Commissioners,

We are glad to have new neighbors and for this property to be improved and maintained, but after reviewing the case file, we have a few concerns. Some of these concerns might be solved by the developer or the permitting process, but he has not reached out to discuss with the community, and the site plan lacks these details. Since this is our last chance to have input in the process, please consider the following:

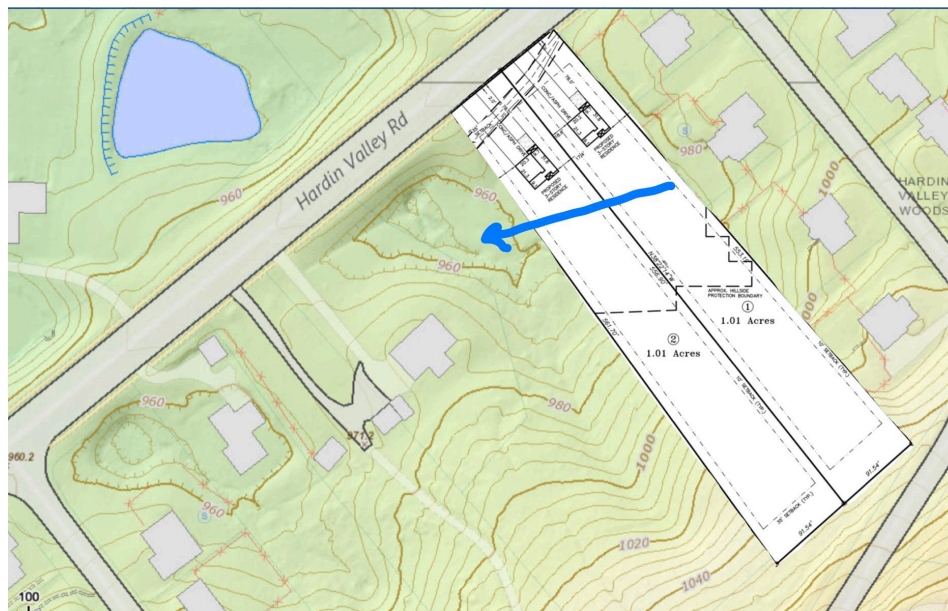
1. That a permanent drainage easement be maintained behind the proposed structures to ensure that storm water from our hillside is not impeded from reaching the culvert on the other side. Note the topo and drainage issue in the picture below:
